# UNITED STATES PATENT AND TRADEMARK OFFICE

APPLICATION NO.	FILING DATE	FIRST NAMED INVENTOR	ATTORNEY DOCKET NO.	CONFIRMATION NO.
10/550,570	09/27/2005	Kai-Uwe Muench	5041.1002	4469

## Office Action Summary

**DETAILED ACTION**

**FIG. 1**

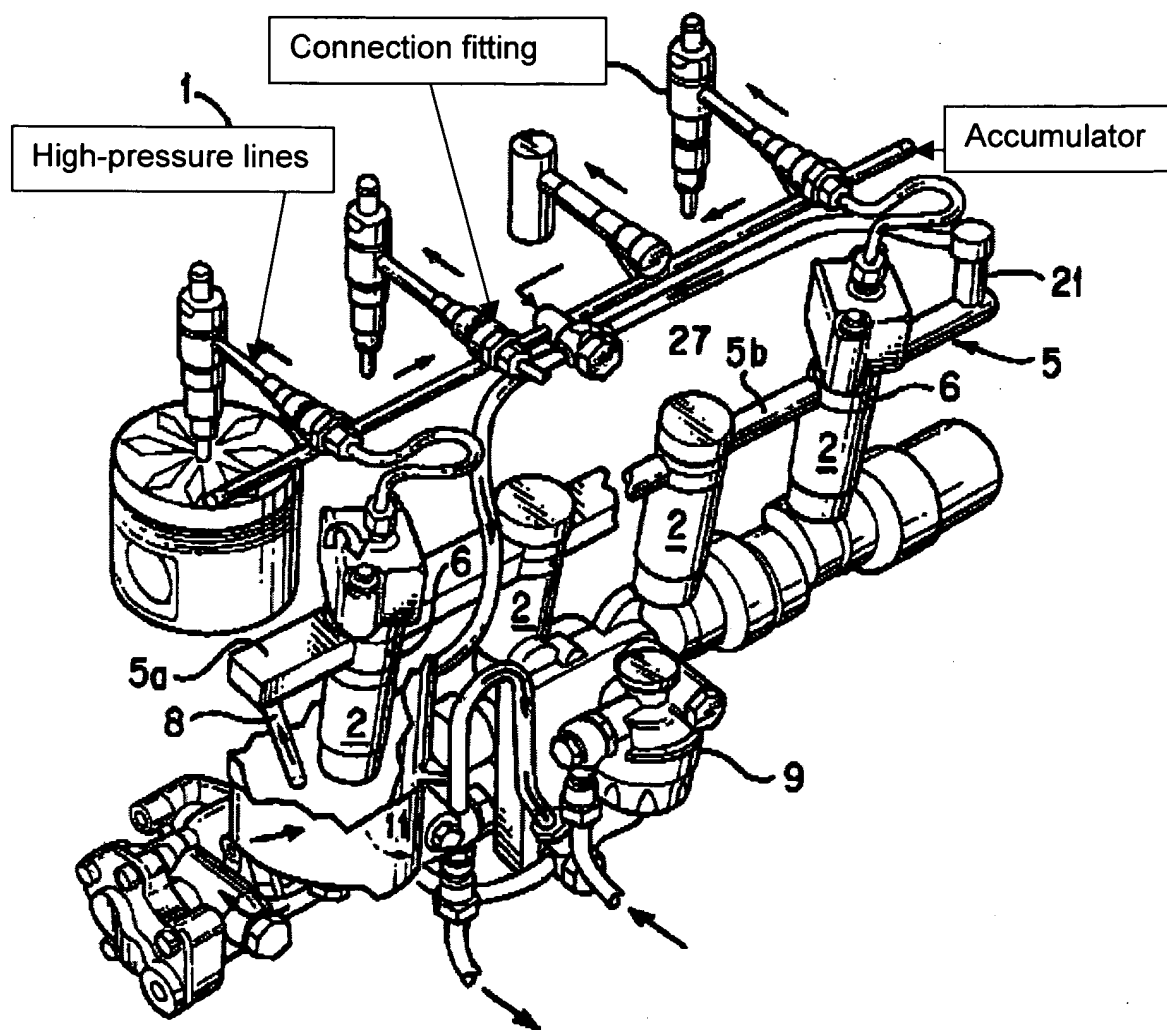
Espey discloses an internal combustion engine that includes an injection system configured as a high-pressure accumulator system, the internal combustion engine comprising: at least one high-pressure pump (2); a tubular high-pressure accumulator (5) having a plurality of connection fittings; a high-pressure supply line connecting the at least one high-pressure pump to the tubular high-pressure accumulator; and a plurality of high-pressure connection lines each connected to one of the connection fittings and configured to provide a valve-controlled (fuel injector valve controlled) flow connection to a respective one of a plurality of injection valves of a cylinder row of the internal combustion engine, wherein each of the plurality of connection fittings is disposed laterally offset relative to the corresponding injection valve, and wherein an absolute magnitude of the offset is the same for each of the injection valves.

Regarding claim 12, further comprising a cylinder head (4) having a plurality of cylinders and pistons, and a plurality of working areas, each formed by a respective

cylinder, piston, and the cylinder head, and wherein each of the plurality of injection valves (see figures) protrudes into one of the working areas.

Regarding claim 13, wherein an orientation of the offset (see figures) for a connection fitting at at least one end of the cylinder row is opposite to an orientation of the offset for the other connection fittings.
